RE: Portable Fire Equipment Asset Defect Report- October 2025

Please find attached the **Asset Defect Report** for the servicing of the **Portable Fire Equipment** at *Shangri-La Cairns* completed this month.

6.2 Metered water supply

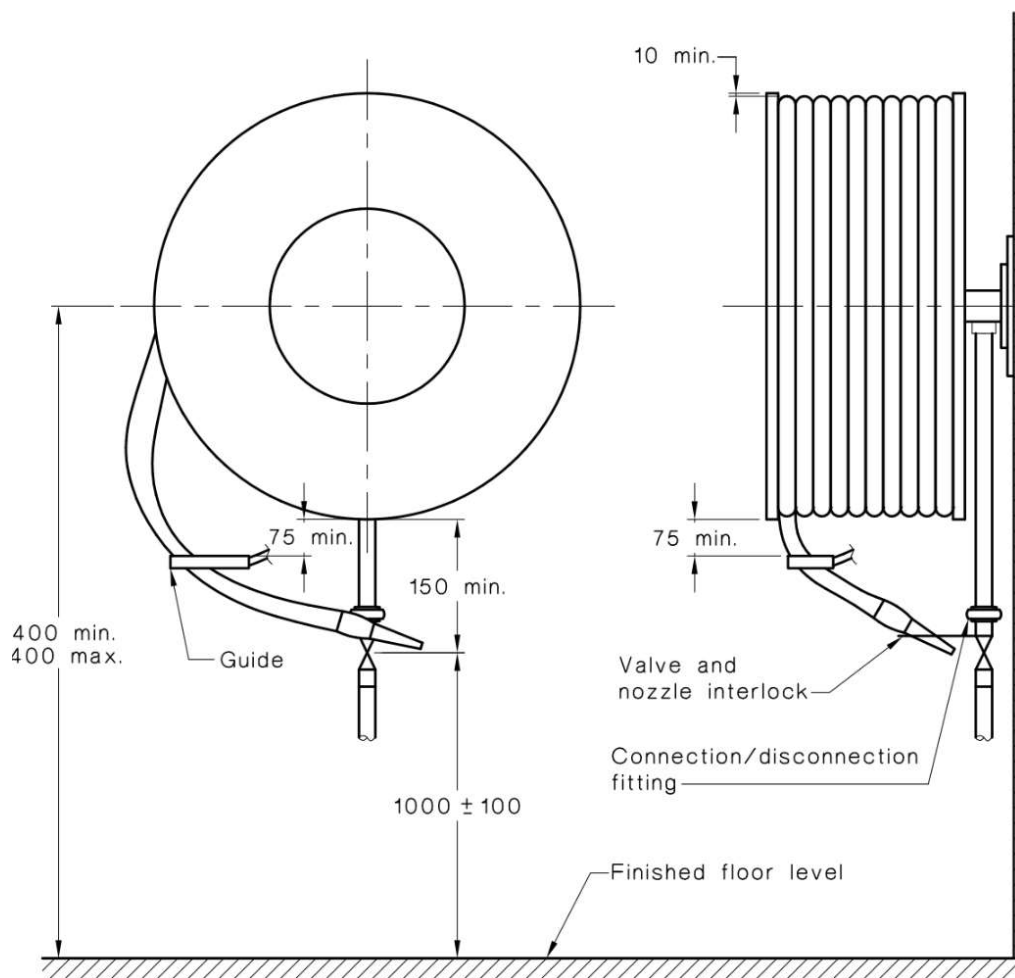
We have attached **photos of the affected assets** for your reference, along with an **excerpt from the Fire Hose Reel installation standard(AS2441)**, which states that *any valve capable of preventing water flow must be secured and locked*. Additionally, we noted that **the stop valve has been installed at an incorrect height**, which is **non-compliant with the standard**.

- (c) Any valve that can prevent flow of water to the hose reel shall be secured and padlocked in the open position. It shall be marked on an attached corrosion-resistant and durable tag, with the following in nominal 8 mm upper case text:

- **Stop Valve Height:** The valves we installed are at 1120mm, slightly above the AS2441 range of 900–1100mm. This minor deviation is due to practical site limitations. The original valves were seized from corrosion, and our fitters attempted to remove them numerous times using several pairs of Stilson wrenches, but they could not be freed without cutting the copper pipework, which would require a plumber and falls outside the scope of our works. The valves are fully functional, and the minor deviation does not affect operational safety. This also explains why the old valves remain in place.

- **Old Valves:** The previous valves had handles removed and spindles cut off (bar one), effectively rendering them openings in the pipe rather than functioning valves. As such, there is no requirement for them to be locked open.
